SOLENOID REPLACEMENT

Doc. No.:	FI-53
Date:	01/31/2020
Page:	1 of <u>5</u> 5

## FIELD INSTALLATION INSTRUCTIONS

Figure 1.

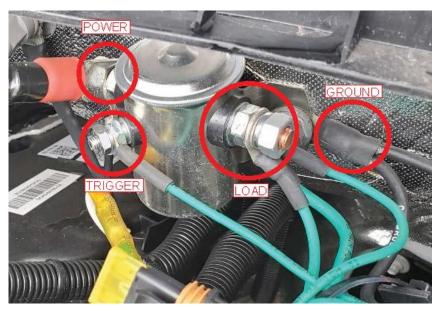
- 1. Disconnect the positive (+) and negative (-) wires from the OEM vehicle battery.
- 2. Disconnect the POWER, TRIGGER, and LOAD wires from the 3-post solenoid shown in Figure 1 below.

3. Unbolt the 3-post solenoid from its mounted location and remove the GROUND wires from mounting bolt when applicable. (Set the hardware aside for future use).

**NOTE:** The 3-post solenoid is "case grounded", which is why the GROUND wires are not connected to a post on the solenoid.

- 4. Remove ring terminal connection from the existing ground wire/wires and replace it with a new ring terminal sized for a #10 post.
- 5. Install the new 4-post solenoid in the same location as the existing 3-post solenoid.

**DO NOT** reinstall the ground wires to the mounting bolt as shown in the Figure 1. The new solenoid has a dedicated ground post.

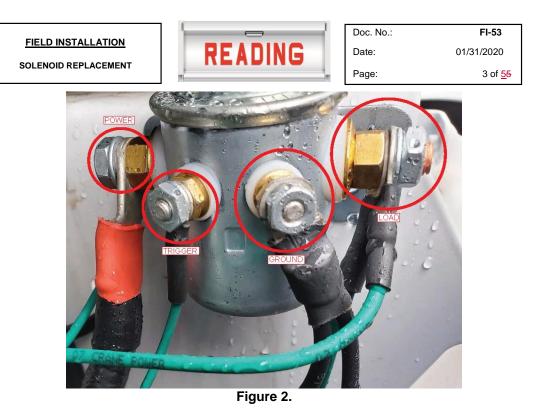
6. Reconnect the existing POWER, TRIGGER, LOAD, and GROUND wires in the locations shown in Figure 2 below.

NOTE<sup>1</sup>: If no ground wire was used on the 3-post solenoid, one must be added.

NOTE<sup>2</sup>: Solenoids may have varying quantities of wires on each post based on application. Be sure to reconnect all wires to their original locations.
Ex. If (2) wires are connected to the LOAD side of the 3-post solenoid, the same (2) wires must be reconnected to the LOAD side of the 4-post solenoid.
